ABQ Studios Expansion
MILL 1 & OVERALL SITE

LANDSCAPE PLAN

LP108

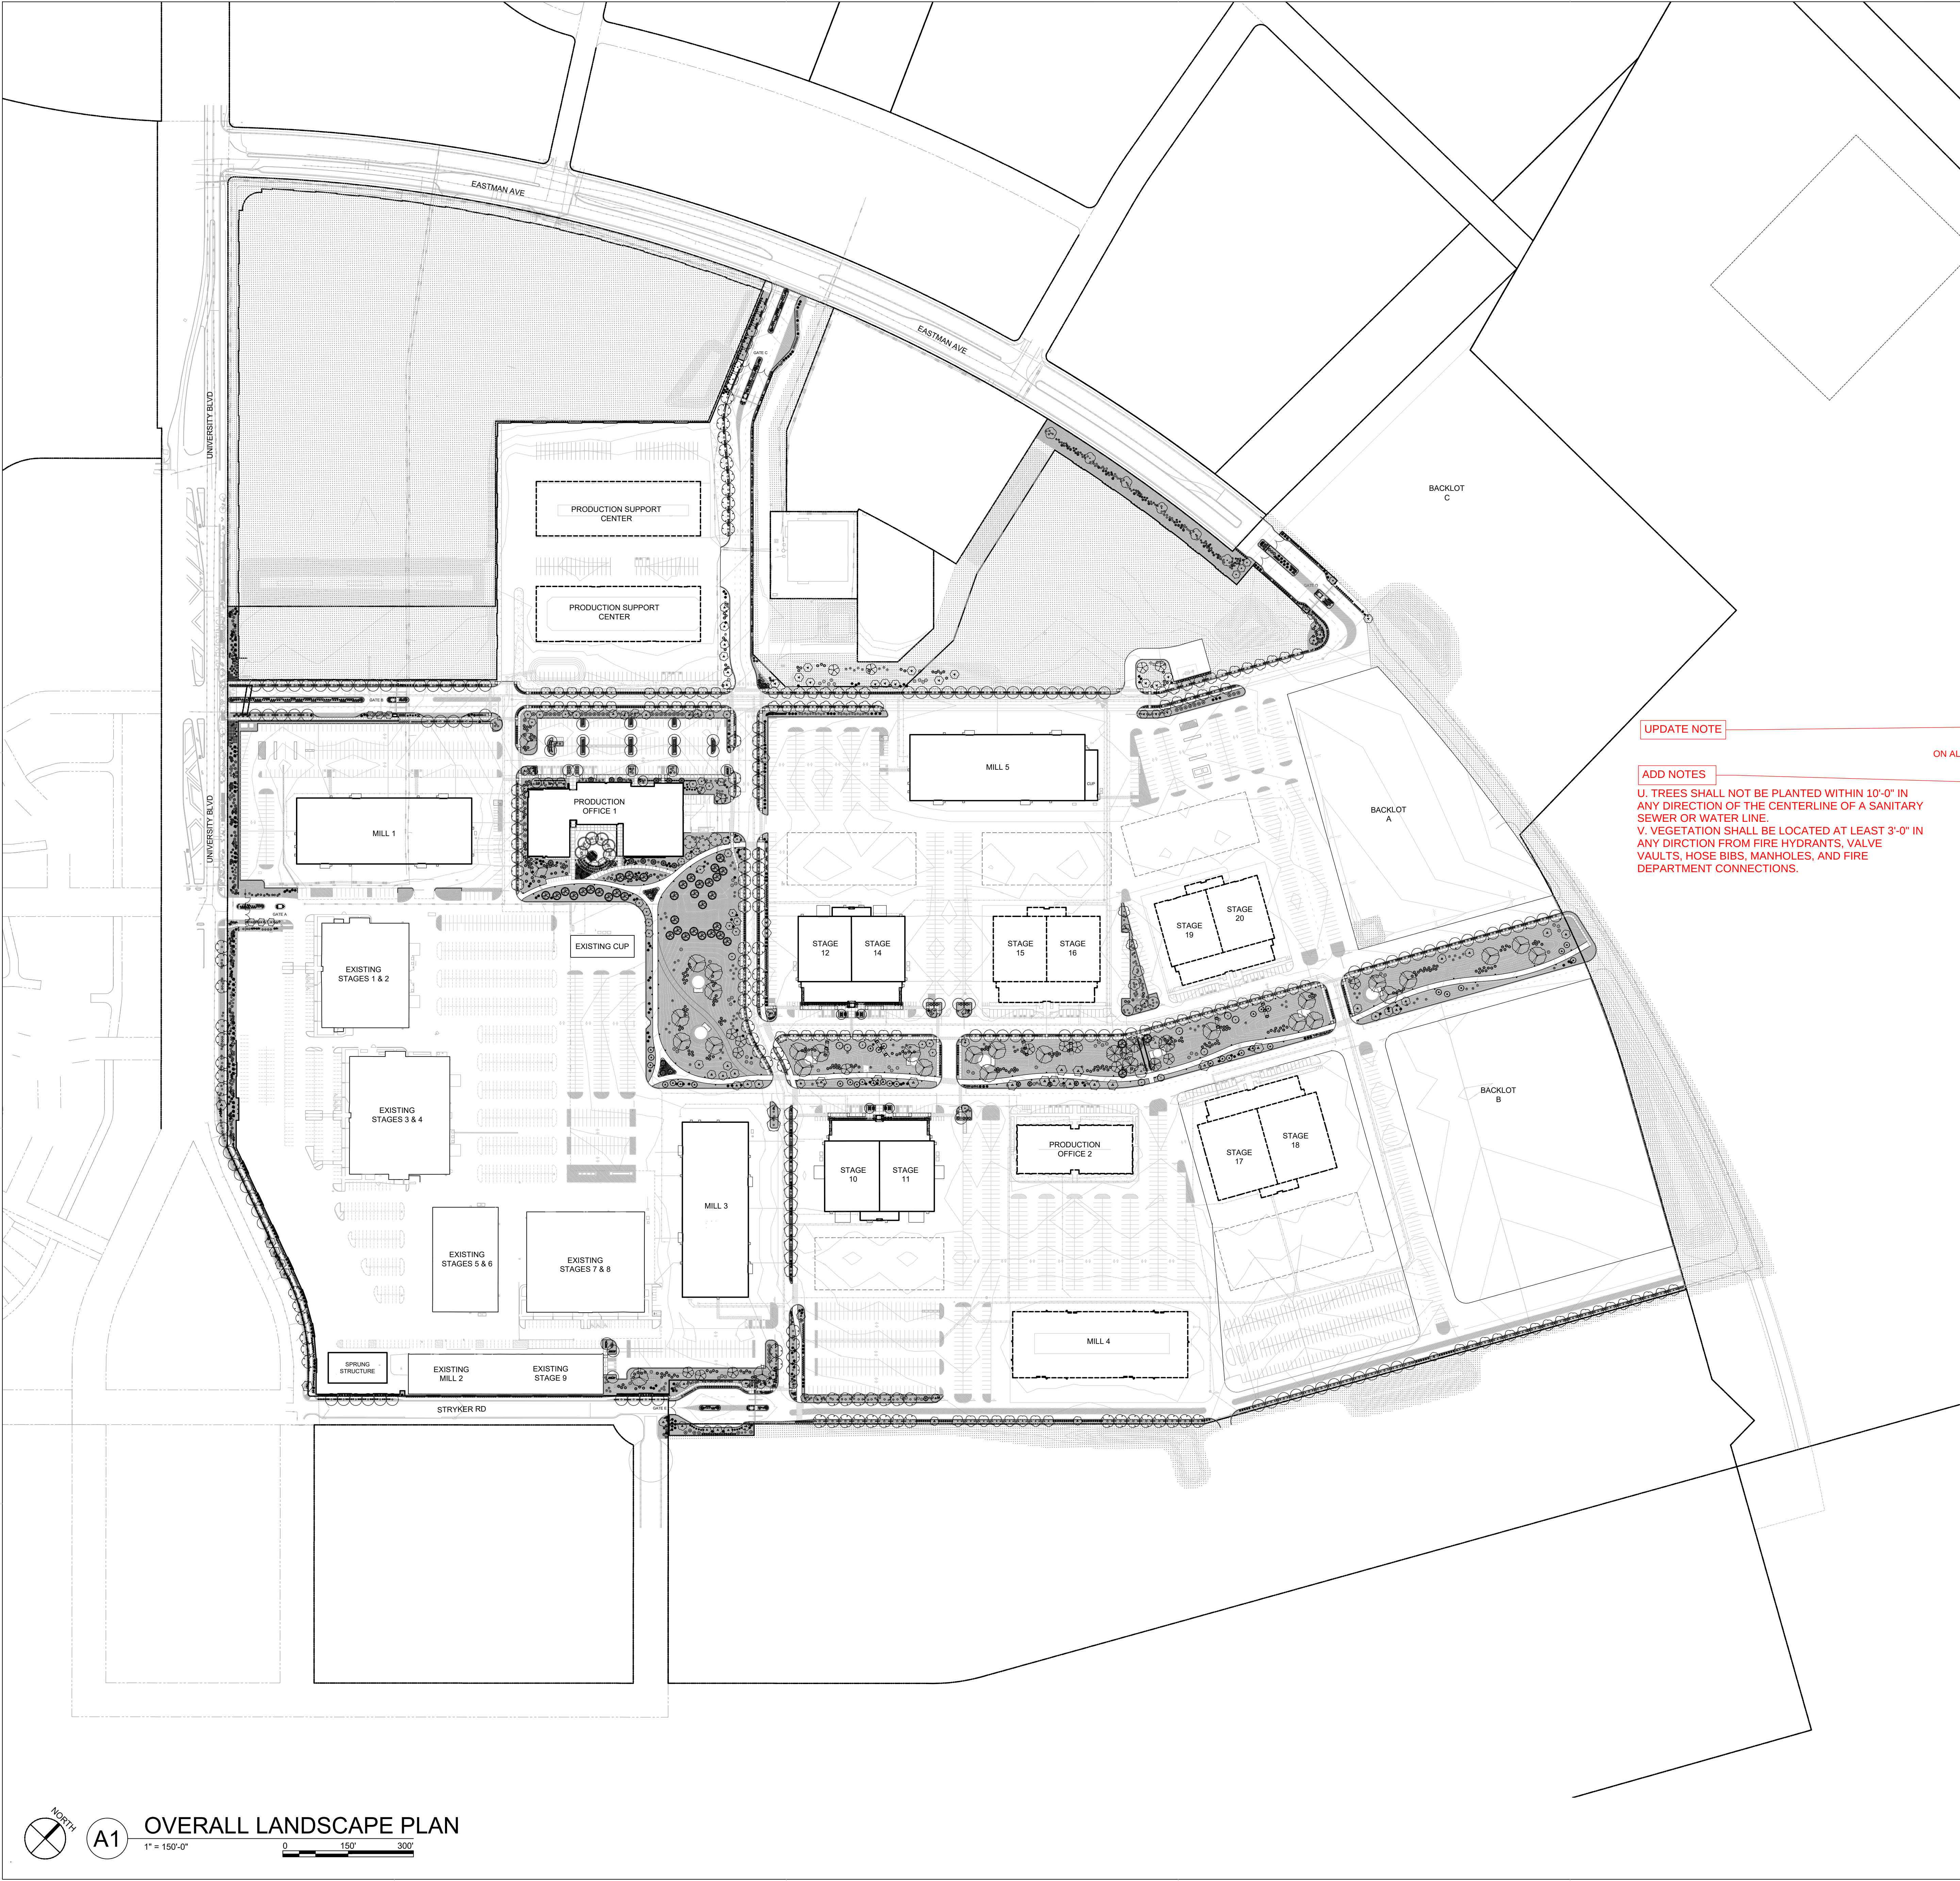
UPDATE NOTE

ADD NOTES

- U. TREES SHALL NOT BE PLANTED WITHIN 10'-0" IN ANY DIRECTION OF THE CENTERLINE OF A SANITARY SEWER OR WATER LINE.
- V. VEGETATION SHALL BE LOCATED AT LEAST 3'-0" IN ANY DIRECTION FROM FIRE HYDRANTS, VALVE VAULTS, HOSE BIBS, MANHOLES, AND FIRE DEPARTMENT CONNECTIONS.

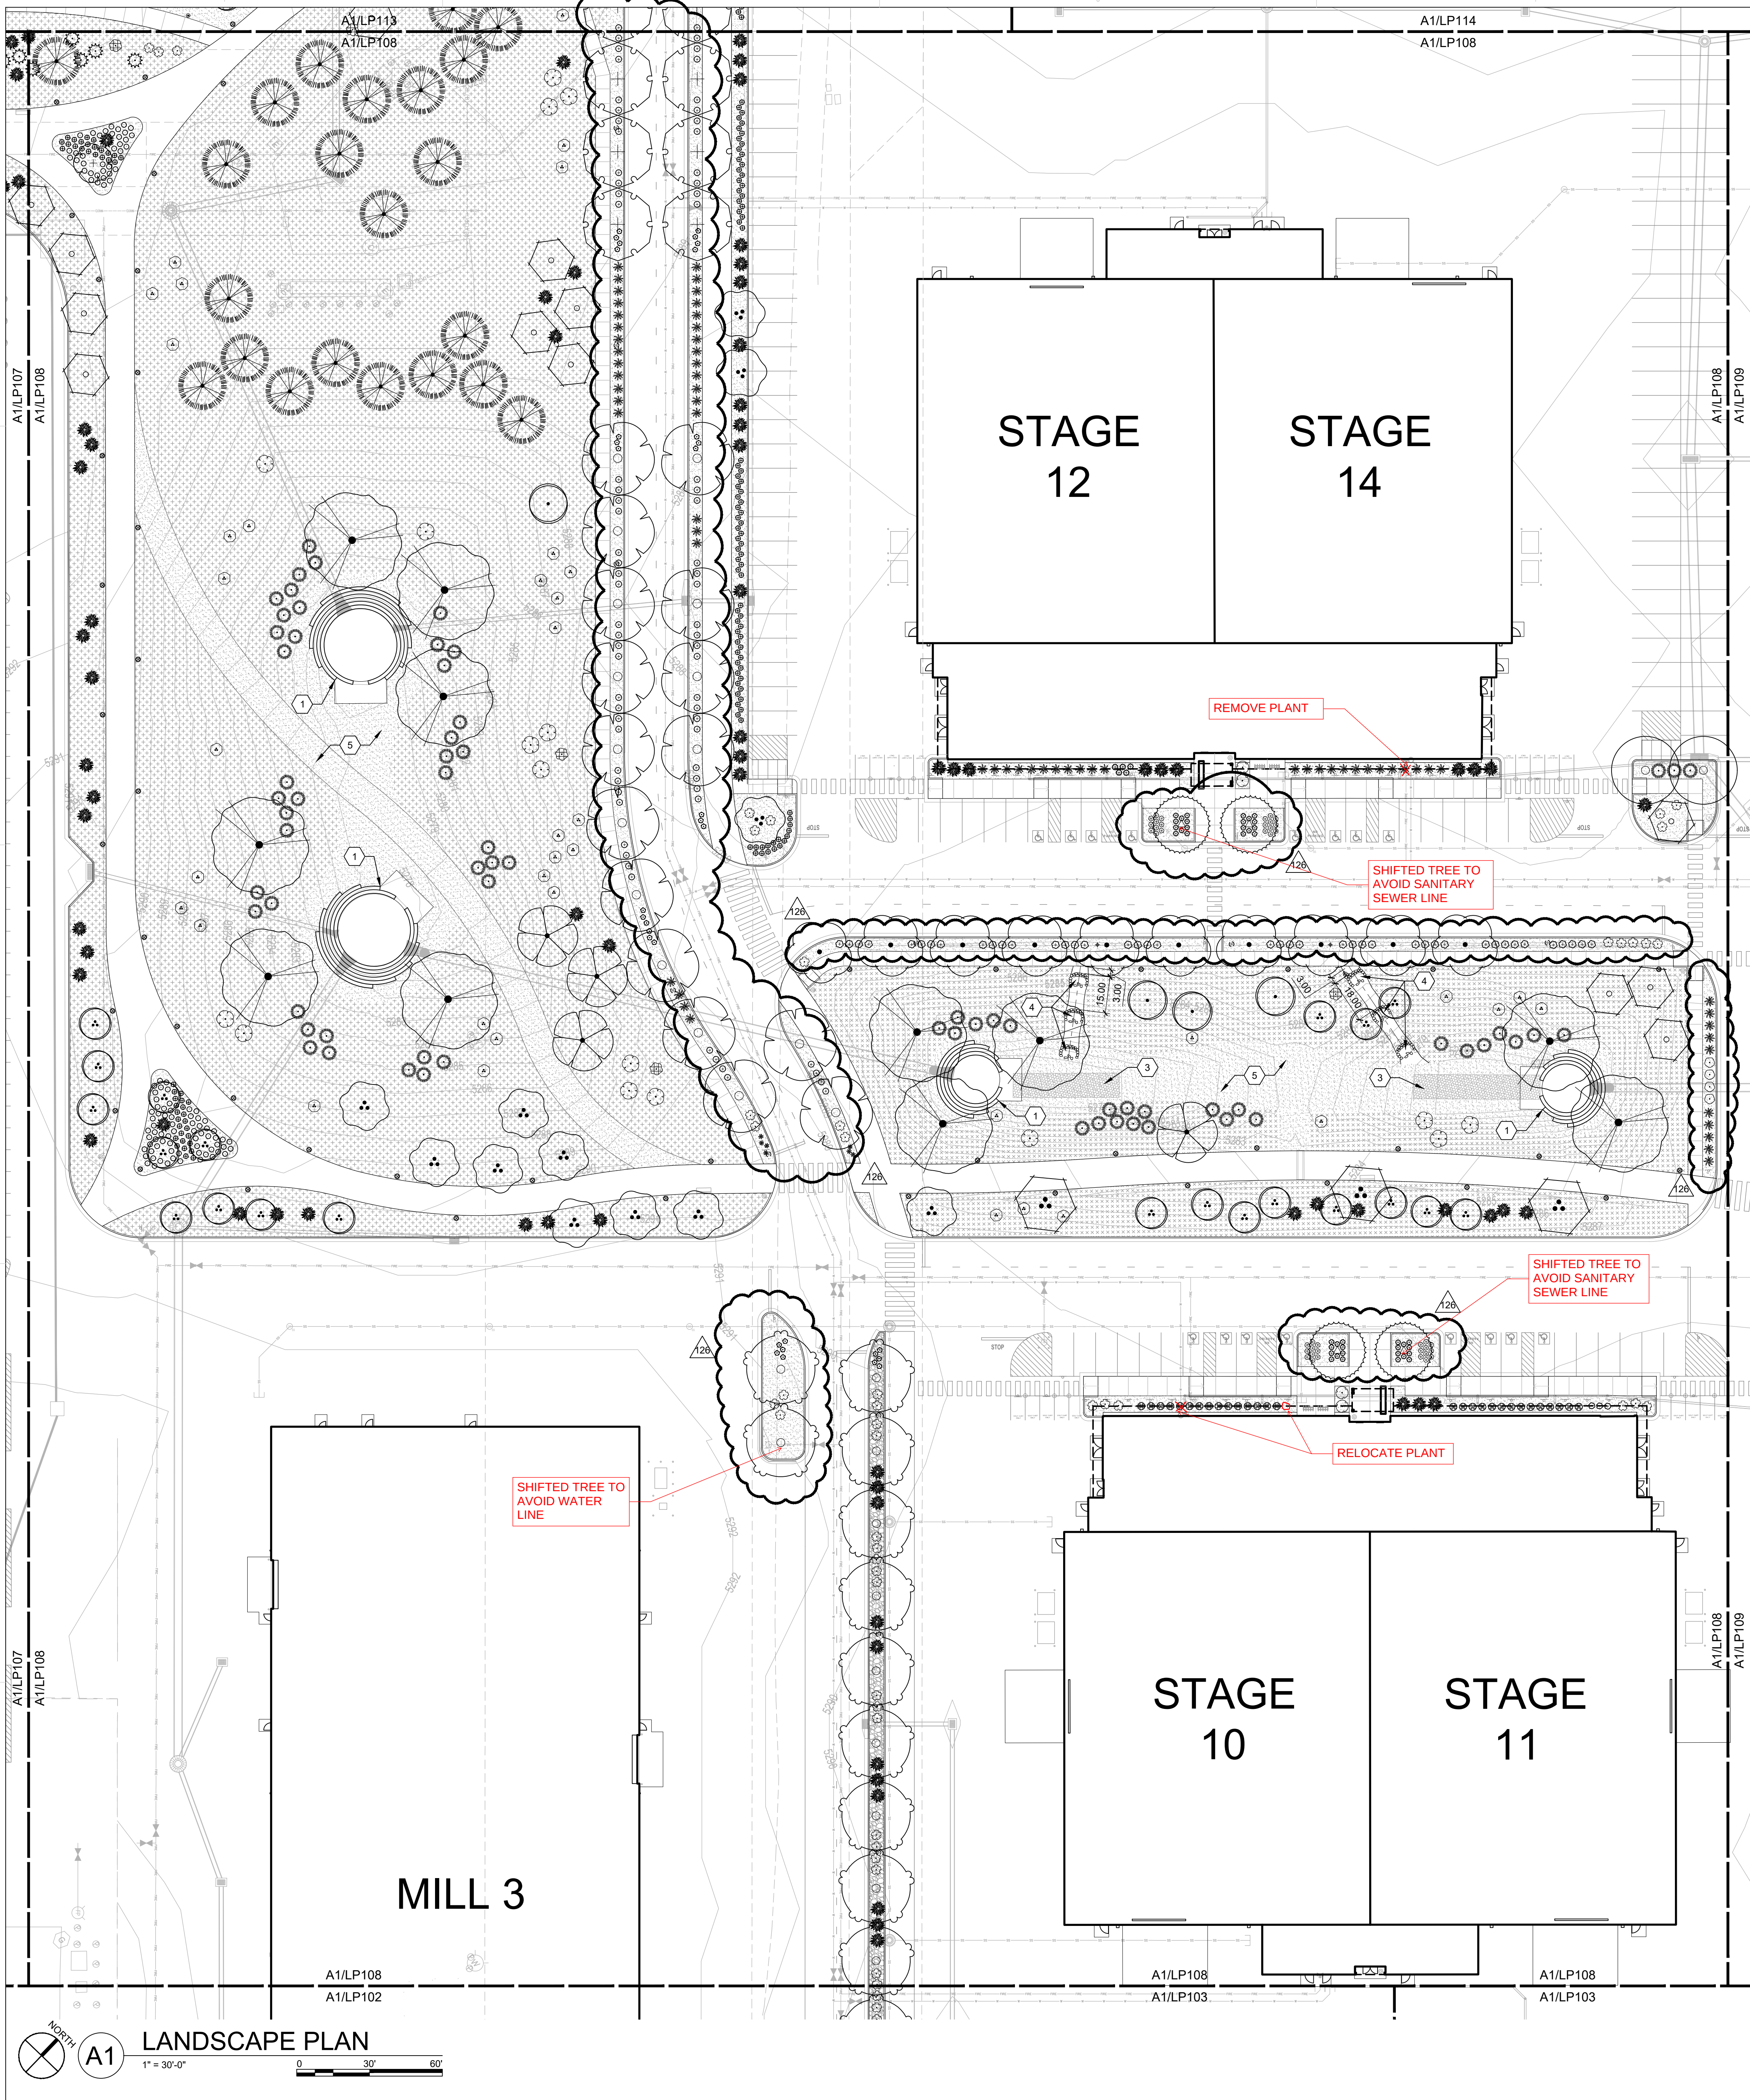
Shredded wood mulch will be removed from project since after plan consolidation the above requirement is met without using it.
